DART AEROSPACE LTD		Work Order:	97887
Description: Crosstube Assembly (412 Low Aft)		Part Number:	D412-664-249
Inspection Dwg: D412-664-249 Rev: B		Page 1 of 2

D412-664-249
ASSEMBLY DETAIL

DRAWING NO. D412-664-249	TITLE CROSSTUBE ASS'Y (412 LOW AFT)	REV. B	DART AEROSPACE LTD ENGINEERING ORDER		D.E.O. NO. D412-664-249-B-1	SHEET NO. SHEET 1 OF 2	SCALE NTS
DRAWN 97	CHECKED SC	MFG. APPR. R	APPROVED MD		DE APPR. H		
DATE 11.05.25	DATE 11.05.31	DATE 11.05.31	DATE 11/05/31		DATE 11.05.31

DRAWING NO. D412-664-249	TITLE CROSSTUBE (412 LOW AFT)	REV. B	DART AEROSPACE LTD ENGINEERING ORDER		D.E.O. NO. D412-664-249-B-3	SHEET NO. SHEET 1 OF 3	SCALE NTS
DRAWN <i>42</i>	CHECKED <i>1</i>	MFG. APPR. <i>12</i>	APPROVED <i>140</i>		DE APPR. <i>11</i>		
DATE 12.08.21	DATE 12.08.30	DATE 12.08.30	DATE 12.08.30		DATE 12-08.30

**D412-664-249
ASSEMBLY DETAIL**

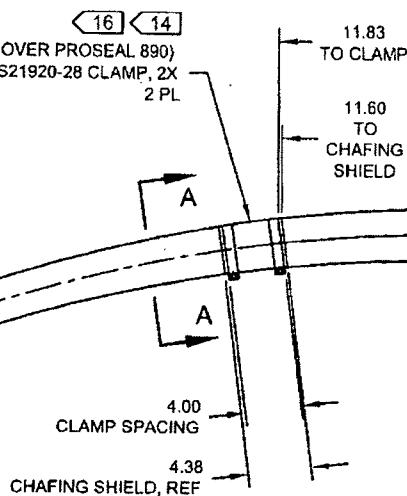
REMOVED ABRASION STRIP IN FAVOR OF A THIN LAYER OF PROSEAL 890. UPDATE INSTALLATION OF CHAFING SHIELDS AND REDUCE TORQUE TO 40-50 IN-LBS. THIS ENGINEERING ORDER SUPERCEDES DEO D412-664-249-B-1

D2856-600-1009 ABRASION STRIP
D3189-1 CHAFING SHIELD (1, INSTALLED OVER ABRASION STRIP)
MS21920-28 CLAMP, 2X
2 PL

D3189-1 CHAFING SHIELD (1, INSTALLED OVER PROSEAL 890)
MS21920-28 CLAMP, 2X
2 PL
